SERVICE BULLETIN

N° 139-615

ATA 00 – INSTALLATION OF SPECIFIC VARIANTS FOR OFFSHORE CONFIGURATION

This Service Bulletin is issued in order to provide the necessary instructions to perform the installation of some modifications required by the Customer to align the configuration of its fleet.

Figure 15

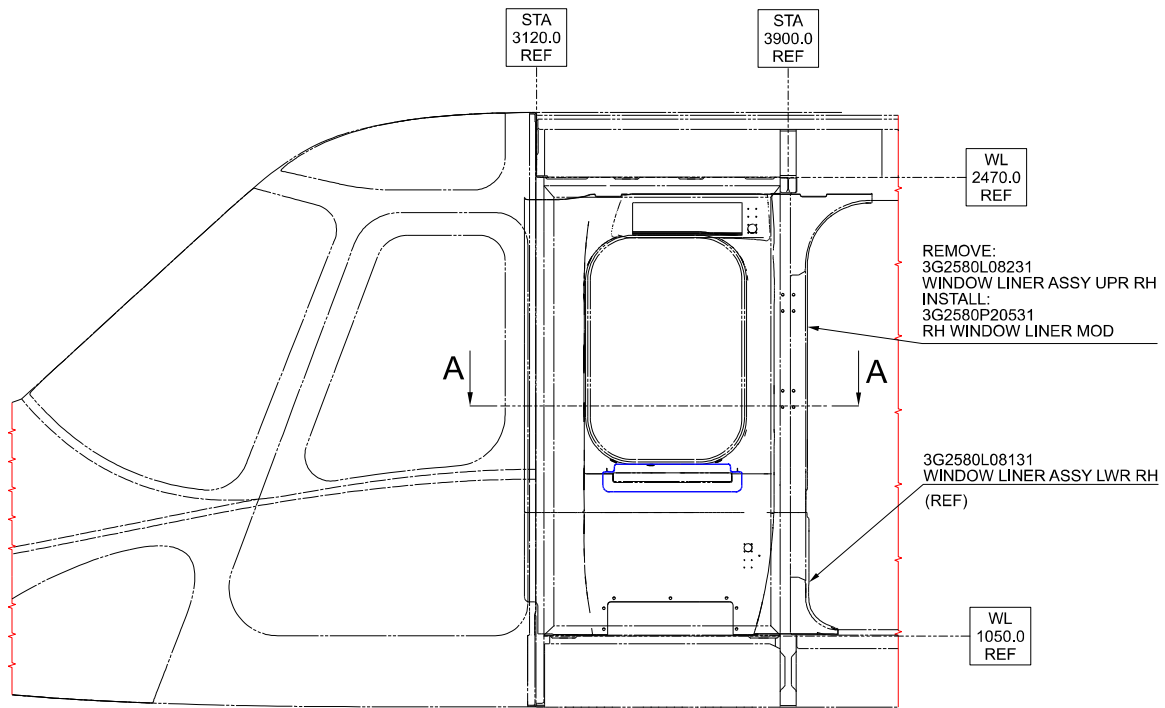
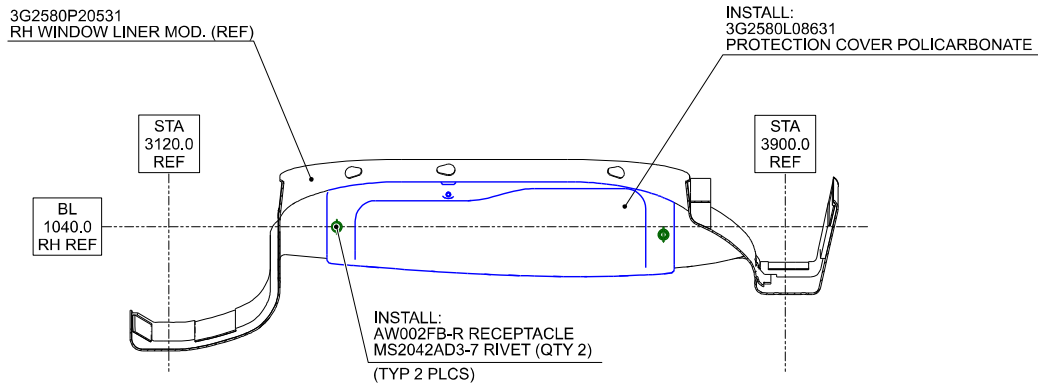
- 2.1 With reference to Figure 15, remove the window liner assy UPR RH P/N 3G2580L08231 and retain the hardware for later reuse.
 - 2.2 With reference to Figure 16 Section B-B and Section C-C, remove the foam from the window liner assy UPR RH P/N 3G2580L08231 in accordance with the dimensioning shown.

- 2.3 With reference to Figure 15 Section A-A, install n°2 receptacles P/N AW002FB-R by means of n°4 rivets P/N MS20426AD3-7 on the window liner assy UPR RH P/N 3G2580L08231 in accordance with the dimensioning shown.

- 2.4 With reference to Figure 15 Section A-A, install the protection cover assy P/N 3G2580L08631 on the window liner assy UPR RH P/N 3G2580L08231 by means of n°2 receptacles P/N AW002FB-R.

- 2.5 With reference to Figure 15 View looking outboard RH, remark the so obtained window liner assy as 3G2580P20531 by means of an indelible marker.
 - 2.6 With reference to Figure 15 View looking outboard RH, install the RH window liner mod P/N 3G2580P20531 by means of existing hardware previously removed.

Figure 17

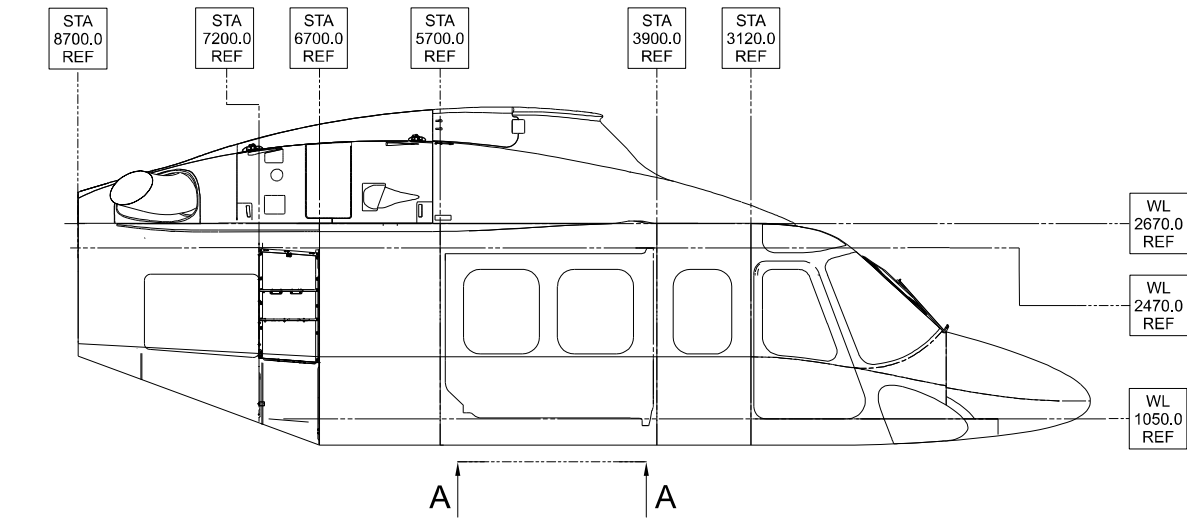
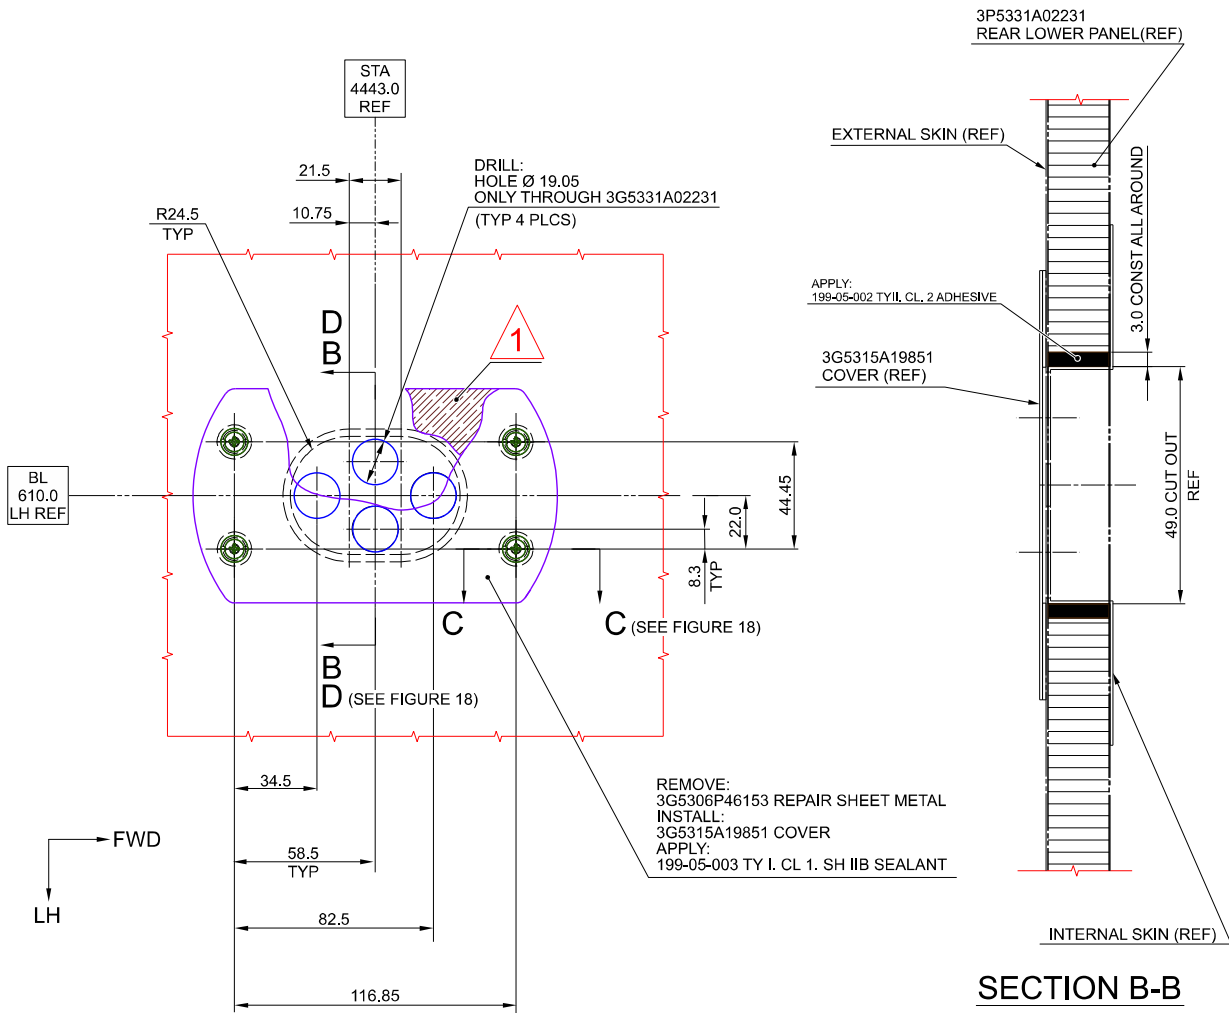
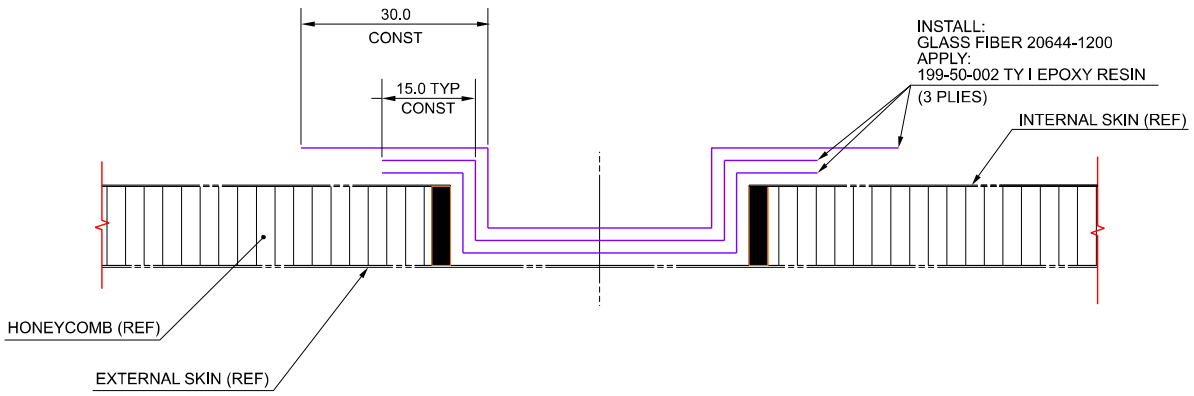
- 2.2 With reference to Figure 17 View A-A and Section B-B, perform the cut out of the rear lower panel P/N 3P5331A02231 in accordance with the dimensioning shown.

- 2.3 With reference to Figure 17 View A-A and Section B-B apply adhesive (C397) on the wall of the cut-out in accordance with the dimensioning shown.

- 2.5 With reference to Figure 17 View A-A and Figure 18 Section C-C, remove the existing inserts.
 - 2.6 With reference to Figure 17 View A-A and Figure 18 Section C-C, drill n° 4 holes $\varnothing 14.25 \div 14.38$ and install n°4 inserts P/N NAS1832-08-3 by means of adhesive (C397).

Figure 18

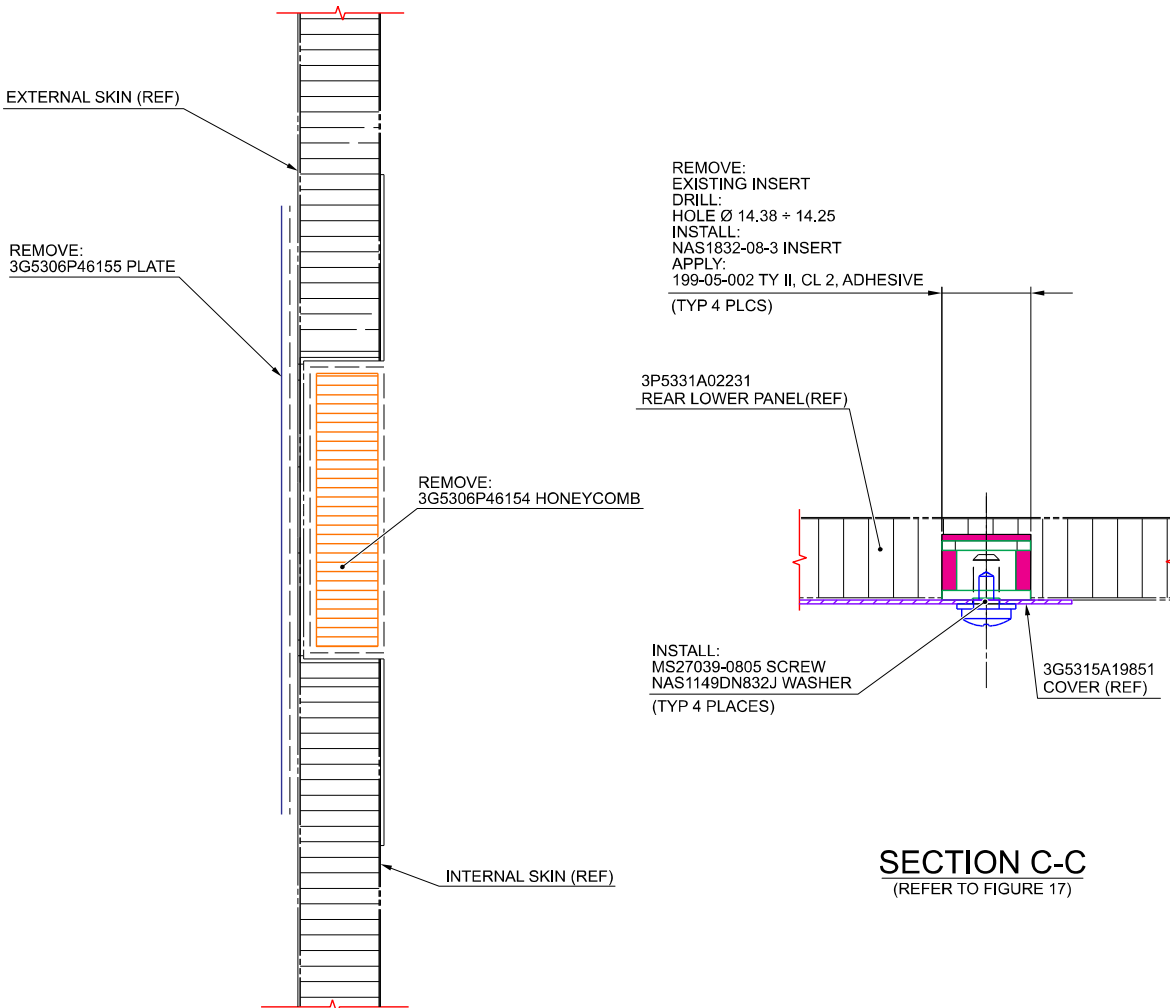
- 2.4 With reference to Figure 18 Schematic Section B-B, install n°3 plies of glass fiber 20644-1200 by means of the Epoxy Resin Araldit LY5138-2 in accordance with the dimensioning shown.

- 2.7 With reference to Figure 16 View A-A and Figure 18 Section C-C, bond the cover P/N 3G5315A19851 to the external skin of the rear lower panel P/N 3P5331A02231 by means of the sealant (C230).

- 2.8 With reference to Figure 16 View A-A and Figure 18 Section C-C, fix the 3G5315A19851 to the inserts P/N NAS1832-08-3 by means of n°4 washers P/N NAS1149DN832J and n°4 screws P/N MS27039-0805.

Figure 19

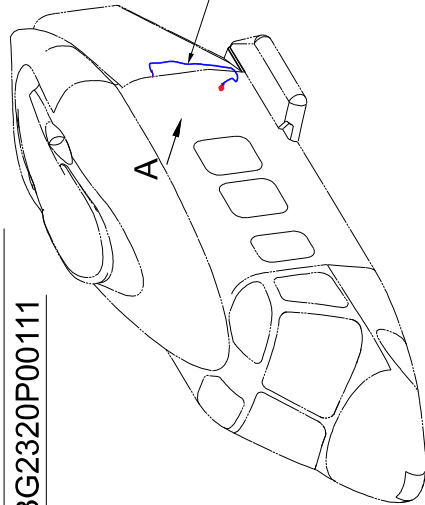
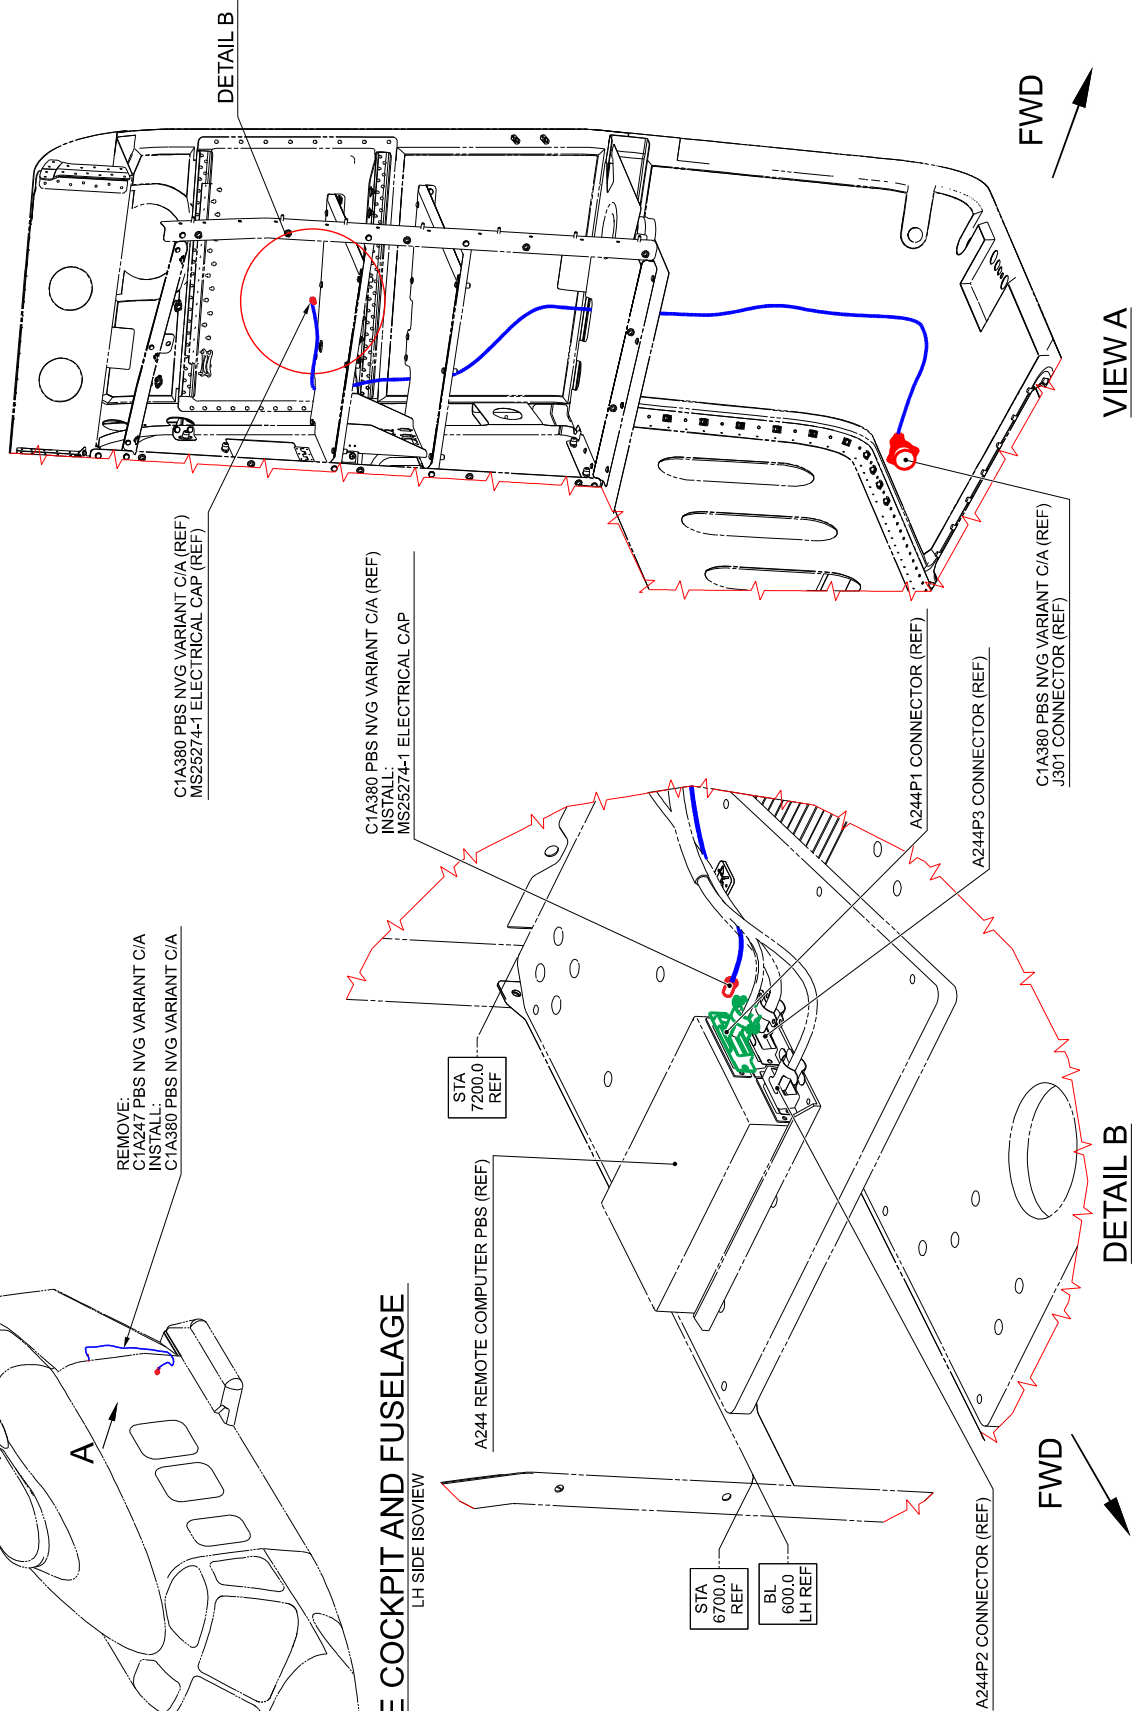
Part VI provides all necessary instruction to install the PBS NVG variant P/N 3G2320P00111. The PBS NVG variant C/A P/N 3G9C01A38001 is installed on the remote computer PBS to modify the illumination of the relative control panel.

- 2.1 With reference to Figure 19 View B and Figure 20 Wiring Diagram, disconnect wire “R1402D22-G” of the C/A C1A247 from pin 24 of remote computer PBS connector A244P1 and stow by means of the electrical cap P/N A583A2610W (CE3047).
- 2.2 With reference to Figure 19 and Figure 20 Wiring Diagram, remark the cable assy as “C1A380” by means of n°2 marker sleeves P/N A578A02-9.
3. Return the helicopter to flight configuration and record for compliance with Part VI of this Service Bulletin on the helicopter logbook.
4. Send the attached compliance form to the following mail box:
